Amendment C143 Public Acquisition Overlay

Summary of Submissions and Planning Comment Table

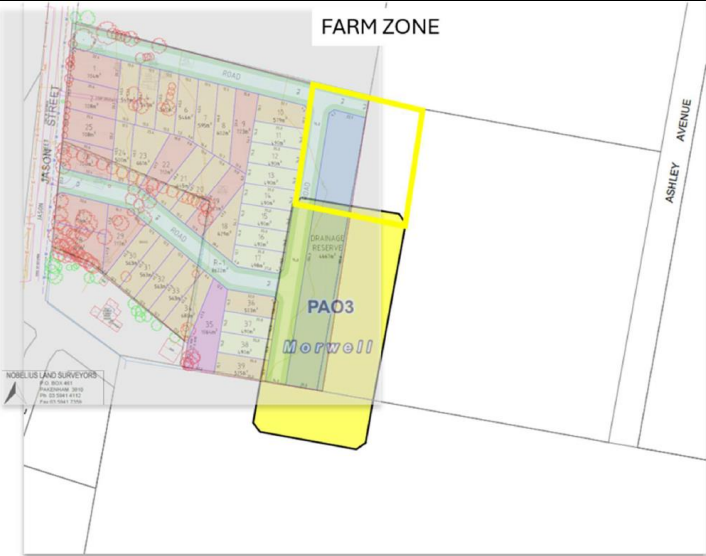
4(a)	Landowner	Objection	a) Location of the PAO will separate the property in two “creating an awkward and unusable rear lot with no road access.” b) Proposed location of drain [to be protected by the PAO] appears to have been based on using the location of the existing drain without sufficient consideration of land ownership or property boundaries. This has resulted in the awkward small parcel without road access. c) Drainage reserve appears to serve a “precinct-wide function, benefiting other landowners while disproportionately affecting us.” d) Request Council to review the Morwell North-West DCP Drainage Report to investigate relocating the drainage reserve to the eastern (rear) boundary of the property.	a) Council officers acknowledge that the location of the waterway would split the property in two if Council acquired the drainage reserve as a ‘reserve on title’. Council officers have discussed with the submitter in meetings prior to this submission that Council could acquire the drainage reserve as an ‘easement on title’ rather than a ‘reserve on title’. Some form of physical crossing of the drainage would also be provided to maintain access to the rear of the property. Council officers have also advised that the intricacies of acquisition are not dealt with at the planning scheme stage. We have advised that if the Amendment is implemented, Latrobe City has the right to compulsory acquire the land within the PAO, however we still have to negotiate the exact area of acquisition and the compensation. It is not in accordance with the <i>Land Acquisition and Compensation Act 1986</i>	No	22/12/2024

Sub No.	Name / Organisation	Support / Objection	Summary of Issues	Planning Comment	Changes to Plan Required? Yes / No	Date submission received
				<p>for Council to determine the compensation and exact area of acquisition at this step in the compulsory acquisition process.</p> <p>b) Council officers have advised the submitter that whilst the location does look awkward and seems to ignore existing boundaries, it actually is the opposite. The location of the drainage reserve was set as part of the Development Plan (whose purpose is to determine the best location of infrastructure such as drainage reserves to facilitate development). The Development Plan contains policy that streets should form the interface with drainage reserves, not the side or rear fences. The location of the drainage reserve has thus been determined by projecting a standard density lot (of approximately 35 metres deep) and road reserve (15m wide) from the eastern property boundary. Council officers consider that the small awkward lot, which is 50m x 110m, would be to be further subdivided into 6 lots (18m x 35m). The further subdivision would likely occur once the land at 65 or 75 English Street has developed as road access would then be available.</p> <p>c) By its nature the drainage reserve does serve a wider precinct function and benefit others in the precinct while constraining the development potential of those with the waterway on their land. The purpose of the drainage reserve is to carry stormwater away from the precinct to the Morwell River. The size of the flows in a high-flow event are anticipated to be too large for a pipe to handle, therefore a vegetated channel</p>

Sub No.	Name / Organisation	Support / Objection	Summary of Issues	Planning Comment	Changes to Plan Required? Yes / No	Date submission received
				<p>was chosen. The vegetated channel also cleans the stormwater before it joins the wider river network as required by State policy in the Latrobe Planning Scheme. A pipe cannot achieve this.</p> <p>Because the drainage reserve benefits the whole precinct, the cost of constructing the drainage project is part of the Morwell North West Development Contributions Plan (DCP). This means whoever constructs the drainage reserve is entitled to a payment/credit from Council equivalent to the cost specified in the DCP. The submitters are not proposing to build the drainage channel so they cannot realise the credit.</p> <p>d) The proposed change has been discussed with council's engineers and the West Gippsland Catchment Management Authority (WGCMA). The following conclusions were reached:</p> <ul style="list-style-type: none"> i. The proposed route is still possible as the correct slope could in theory be achieved, however it would be achieved at a much higher cost due to significantly increased earthworks required. ii. The scope of earthworks required would be significantly increased because the channel would not sit at the bottom of the valley but on the side. This means the valley bottom would need to be filled in (west of the new alignment) and additional cutting would be needed on the east side of the alignment to grade the current ground level down to the channel. Additional fill and cut works are required to ensure all stormwater can drain by
